MOTORCYCLE	10/7/09	M2009-032R
------------	---------	------------

SAFETY RECALL This modification has top priority. This bulletin must be performed immediately to ensure customer safety.
 NOTE: Bulletins that announce a recall will have an "R" at the end of the bulletin number.

2005 FZ6, YZF-R1, AND FJR1300 FACTORY MODIFICATION CAMPAIGN – Unstable Engine Idling

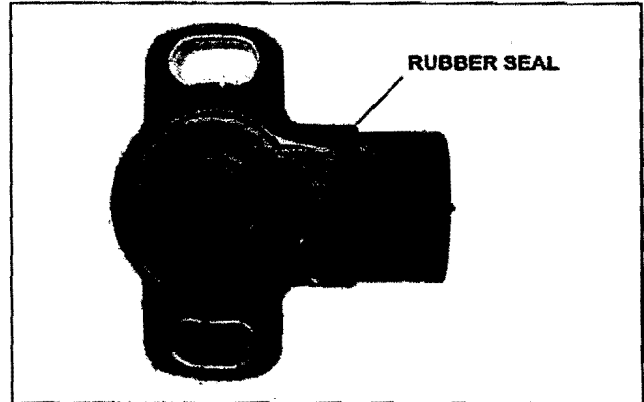
To replace the TPS, follow the applicable Service Manual:

Refer to "Checking and Adjusting the Throttle Position Sensor" in the Service Manual.

Be sure to remove the old TPS seal from the throttle body if it did not come off with the TPS. Otherwise, the leftover seal may cause the new TPS to exhibit an unstable idle.

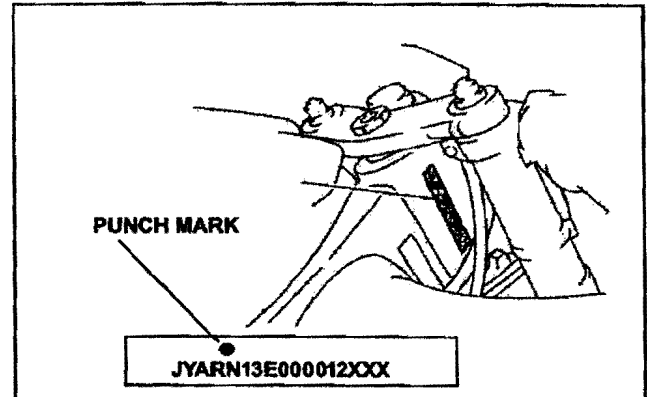
When the modification is complete, put a punch mark above the VIN (frame number) as shown.

Before modifying a unit, check for this punch mark.
